45654-OTH Fiordland Lobster

Restriction of access via installation of a permanent fence to the commercial port area of Deepwater Basin, Milford Sound Piopiotahi.

Realnz Limited

Figure 1 – aerial view of the site showing vehicle track and suggested revised location of fence line

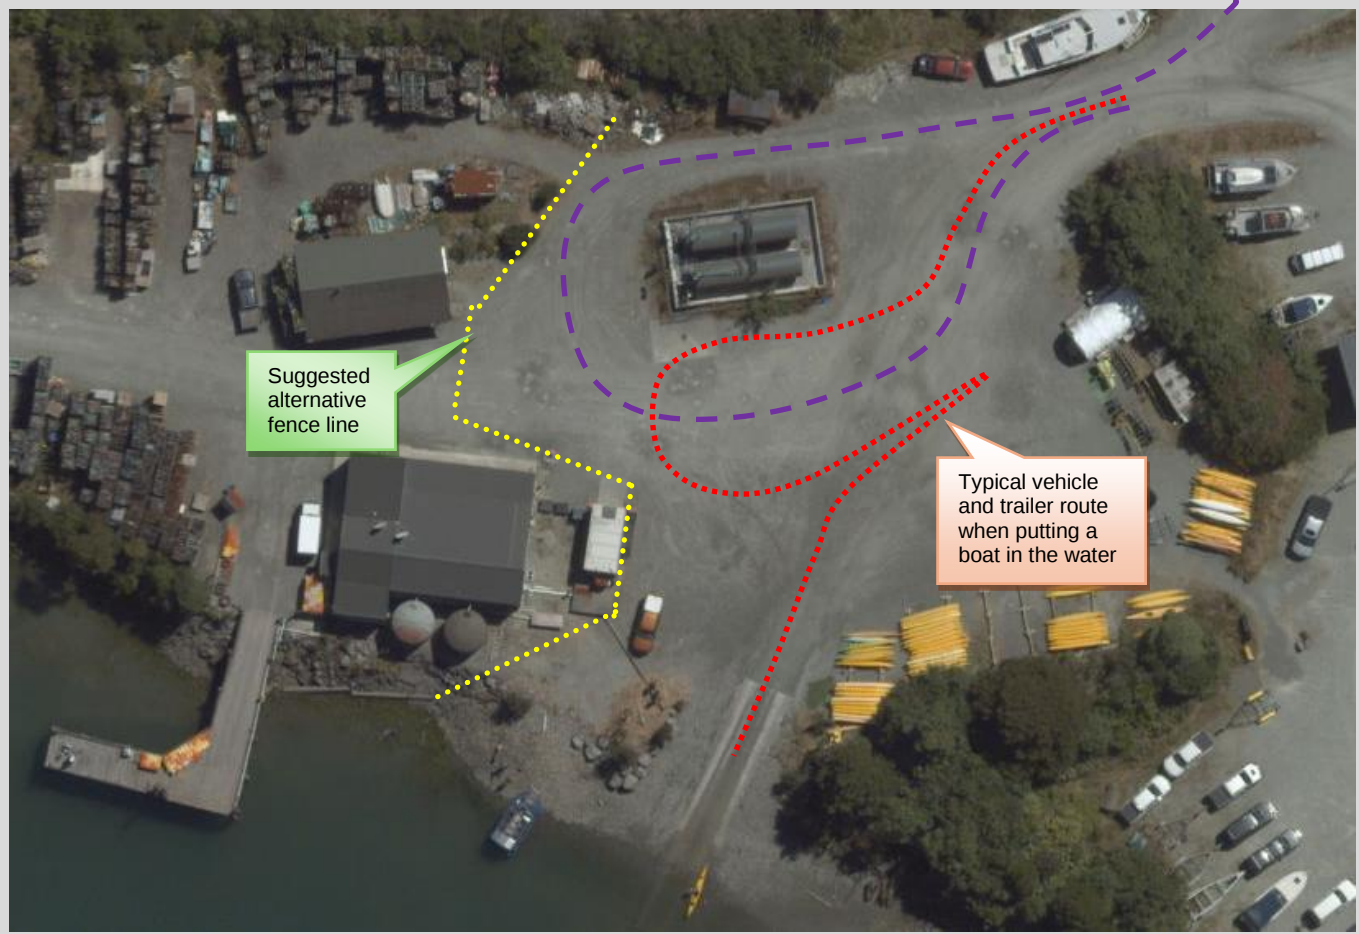
- Encroachment into the area available to vehicles towing vessel trailers (especially a large vessel such as the “Te Namu”) to manoeuvre when utilising the Deepwater Basin boat ramp when putting vessels into the water. Also, the proposed fence location has the potential to affect the route used by truck and trailer units to turn around to either exit the area or access the helipad or Milford Sound Tourism infrastructure.

When manoeuvring a vehicle towing a trailer carrying a 9m plus vessels typically swing towards the entrance to the Deepwater Basin wharf then drive back towards Rosco Milford Sound kayak shed then reverse down to the public boat ramp to keep clear of the kayakers on the eastern side of the Deepwater Basin hardstand. Consequently, the proposed fence would be more user friendly to other users if the fence had a dogleg in it bringing the fence line closer to the "White House". Refer figure 1 (red line). Also, vehicles such as the fuel tanker and Northern Southland Transport trucks effectively drive around the western side of the Allied Petroleum tanks to either drive back down Deepwater Basin Road to exit the site or to the helicopter pad to deliver supplies (and collect waste) that are then transferred to and from the huts on the Milford Track (refer purple line). Materials for Milford Track maintenance (for the track section west of the divide) are likewise staged from this helipad. Large trucks accessing Milford Sound Tourism (MST) Wastewater Treatment Plant and other infrastructure adjacent to this plant also use the same route.

We understand that it is proposed that "Access B" in the fence will be padlocked and only available for access for the fuel tanker. At the very least both gates, will need to be wider (than indicated in the drawing included in the application) to avoid the tanker and trucks especially with trailers clipping the fence when passing through the fence or being required to reverse when manoeuvring through the gates. In addition, there other parties such as the driver of the Northern Southland truck that need access through this gate hence a padlock is not practical, a further electronic lock with an access code would be more realistic.

- Reconsider the design of the fence; either change the fence line to provide more room for vehicles to manoeuvre when utilising the area or ensure the gates are wide enough to provide for truck and trailer units to drive around the western side of the fuel tanks to drive back towards the east to either exit the area or access the helipad or MST infrastructure. Given how the area is used by the likes of kayakers (pedestrians) it is essential from a safety perspective, that vehicle reversing is avoided, if at all possible. That is, this fence design (including gates) should be such, that there is no cause for fuel tankers or Northern Southland Transport trucks (incl trailers) to reverse when transiting through the Deepwater Basin hardstand area.¹
